STATE OF WASHINGTON
DEPARTMENT OF ECOLOGY

February 11, 2021

**Re: Request for construction of scale station near closed ash landfill
Recomp of Washington Site, Cleanup Site ID (CSID) 378**

Approximate location of scale and scale house

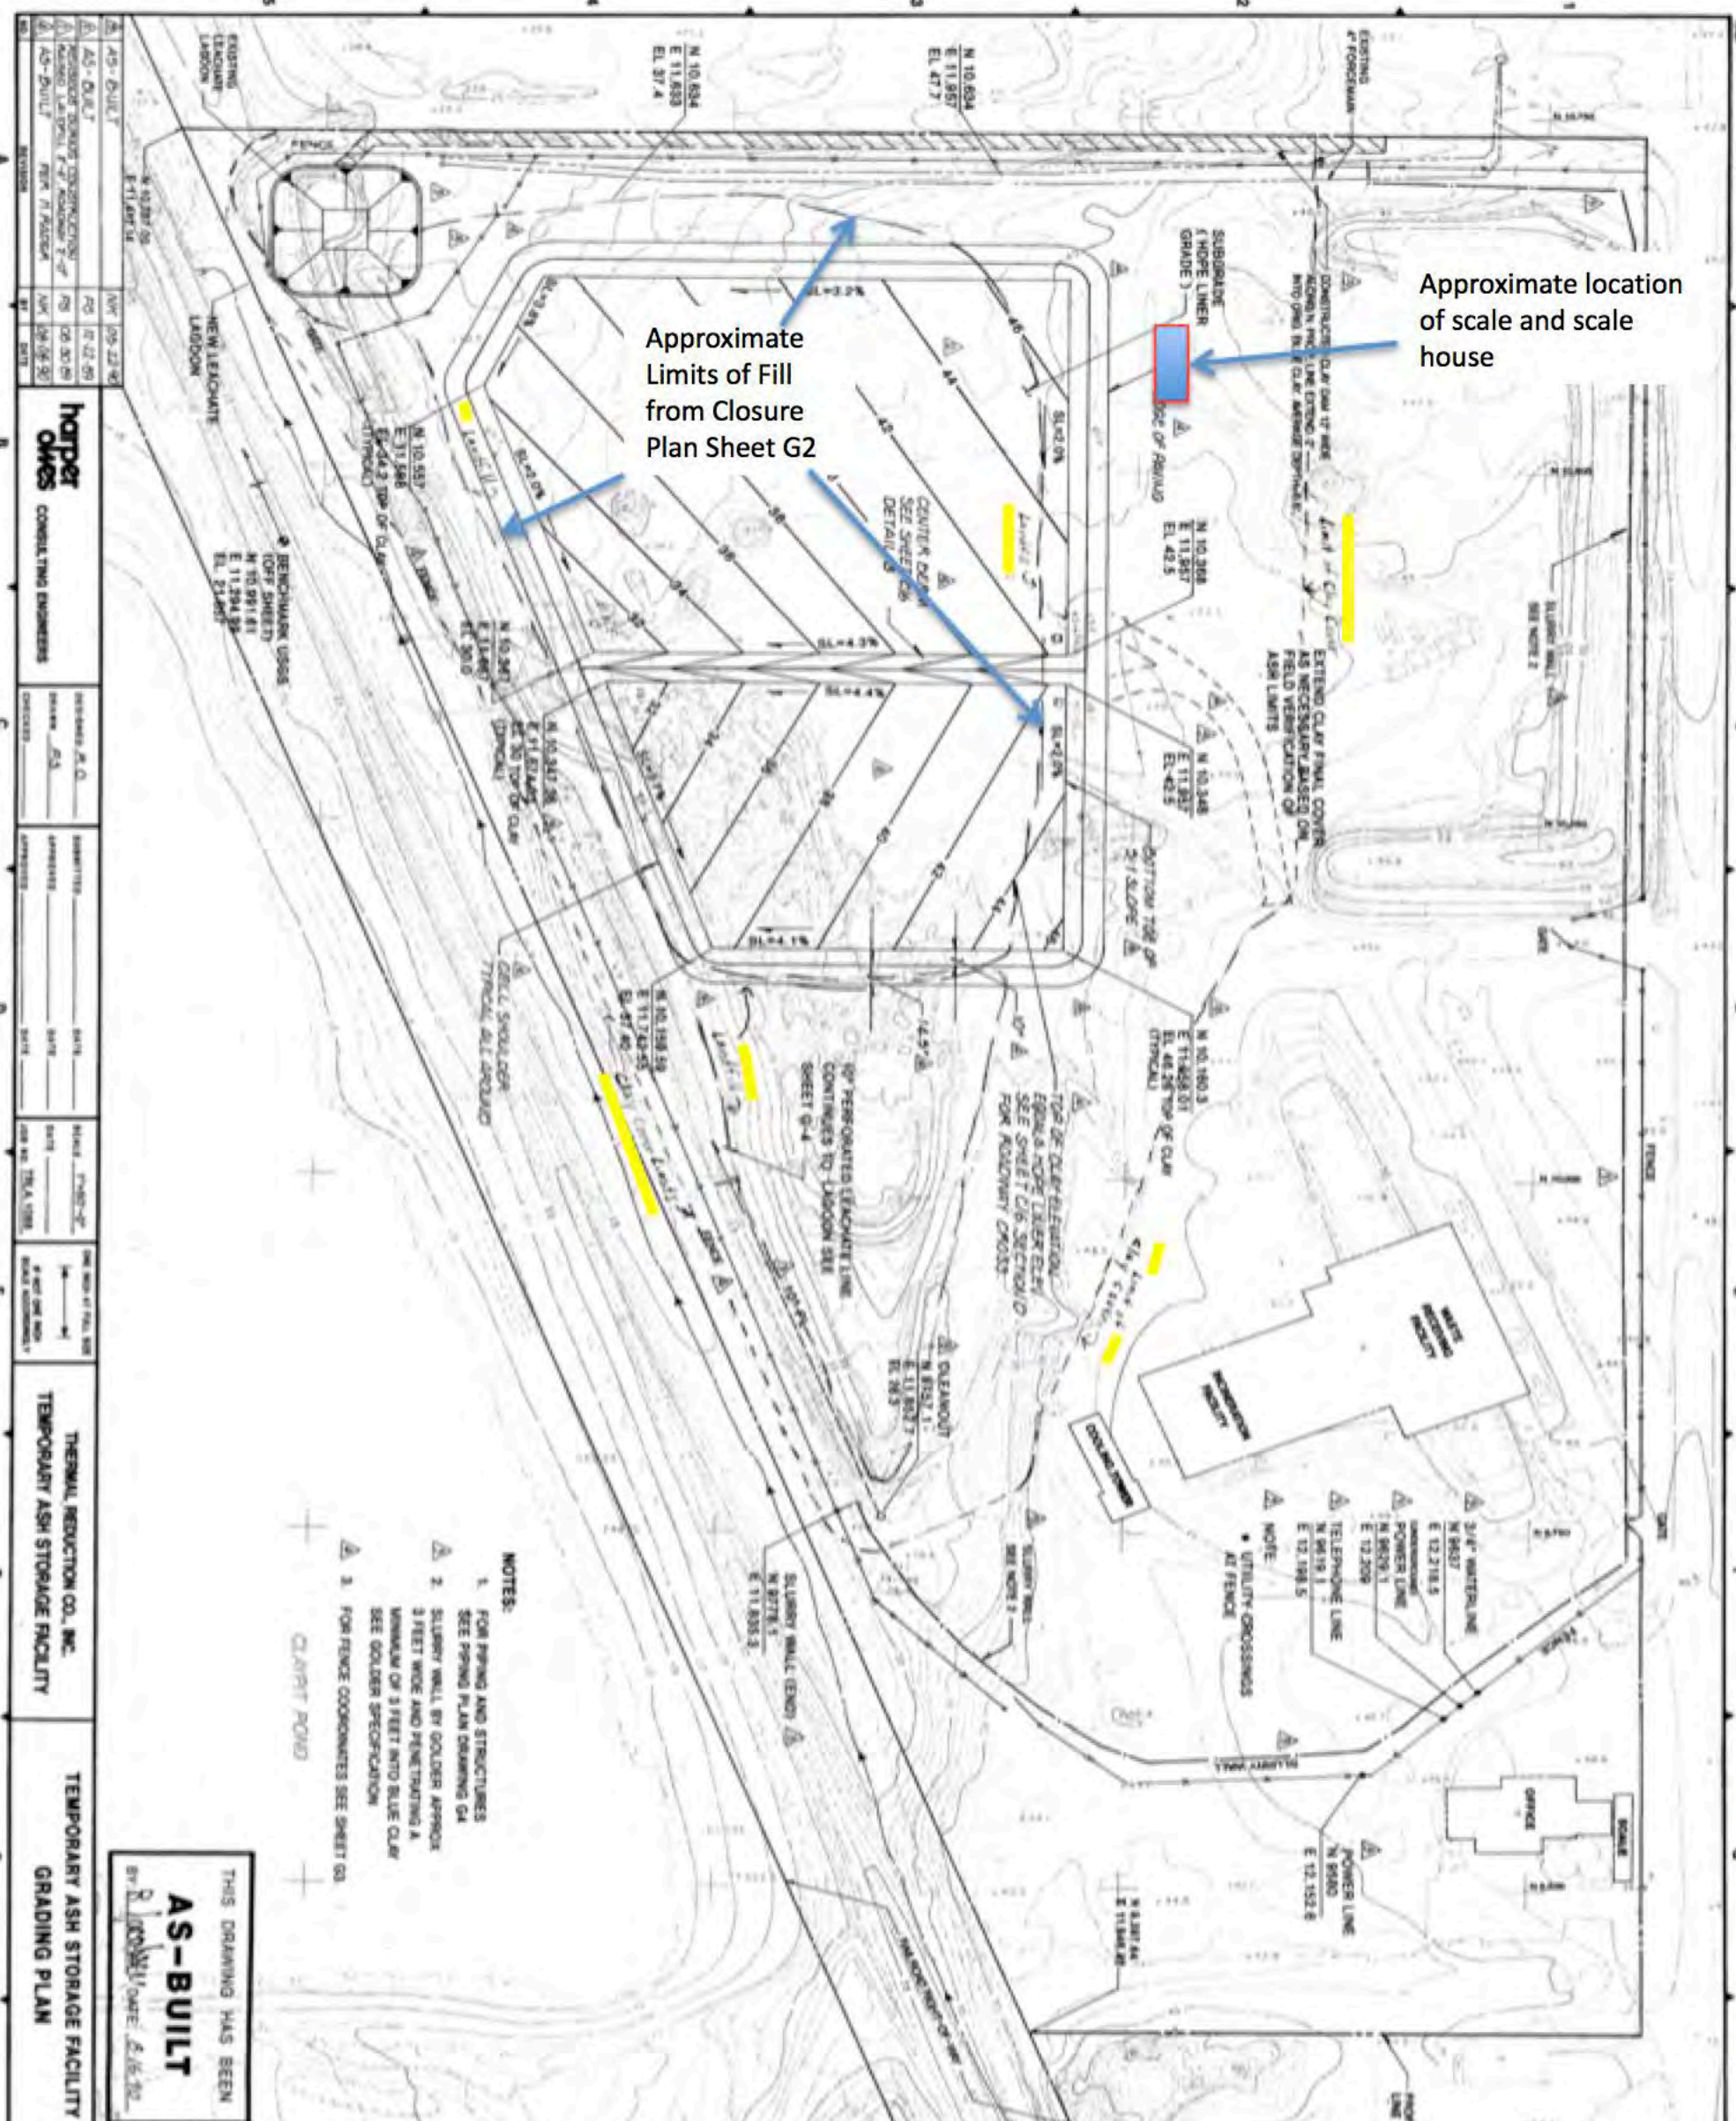
The proposed aboveground scale is located east of the approximate boundary of the closed ash landfill. The June 28, 1989 Design Report states the former ash landfill that was closed in 1989 was constructed with a 24-inch thick cover of compacted clay with a permeability of less than 10^{-6} centimeters per second (cm/sec). A temporary ash storage facility was constructed on top of the closed ash landfill, and this facility operated from 1989 to 2001. The subgrade of the temporary ash storage facility consisted of an 80-mil high density polyethylene (HDPE) liner covered by 18 inches of native compacted soil. The 1996 Annual Report contains a Facility Cross Section by Vasey Engineering that shows the ash landfill extends east of the temporary ash storage facility with an uncertain east boundary, and that the clay cap extends over the ash landfill. An asphalt surface was constructed over the entire closed landfill near the area of the proposed scale.

The proposed scale extends 18-inches into the surface soil. Shallow soil borings should be sampled up to 5-feet deep to confirm that the proposed scale is not constructed above the closed ash landfill. If the proposed scale penetrates into the clay cap above the ash

fill, a welded, 60-mil HDPE geomembrane should be furnished beneath the scale foundation and the design should ensure that stormwater does not infiltrate to the surface of the geomembrane.
